Migrating from STR91xF to STR91xFA

This document describes at the system level the feature enhancements and silicon fixes incorporated in the new STR91xFA devices, compared to the original STR91xF devices.

Figure 1. Memory accelerator

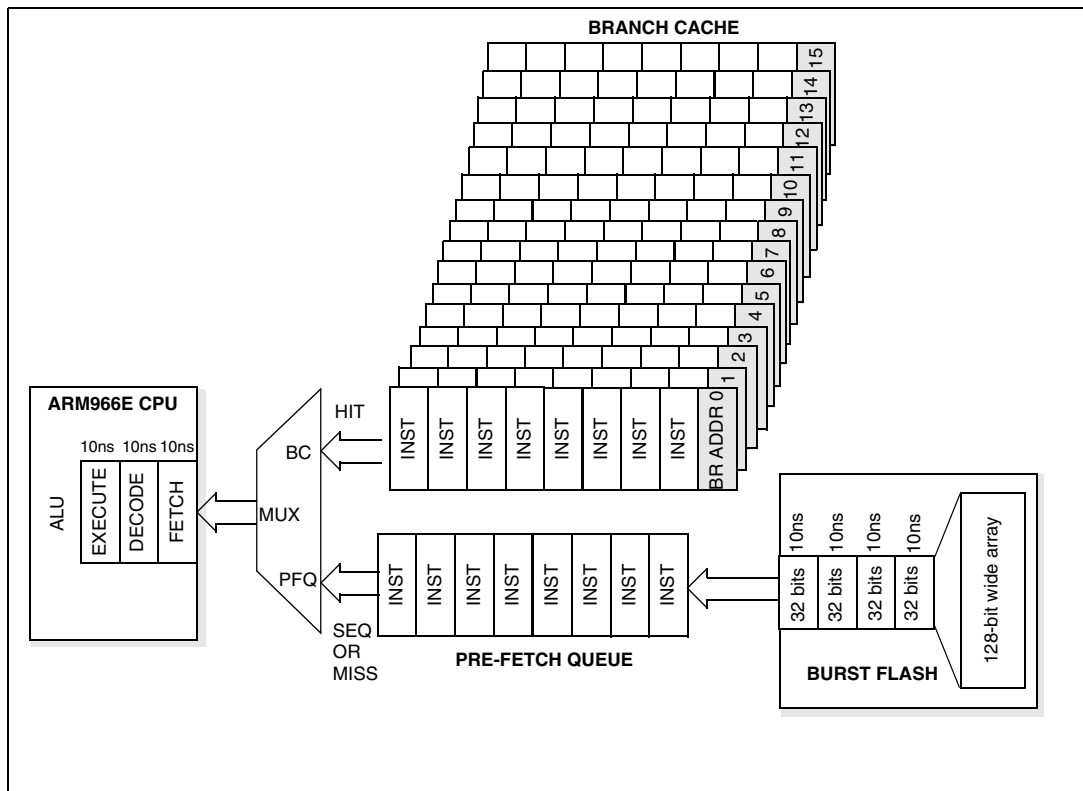
In STR91xFA, the number and size of branch cache entries was increased from five entries with four words each to 16 entries with 8 words each. The 16 entries are partitioned into 15 general purpose entries plus one entry dedicated to the VIC. The branch cache serves to accelerate instruction fetching from the burst-mode flash memory in looping code.

Impact: Performance enhancement. Fewer wait states will be incurred in response to program branches taken repeatedly. Aside from the performance improvement, the change is completely transparent to both systems and application software.
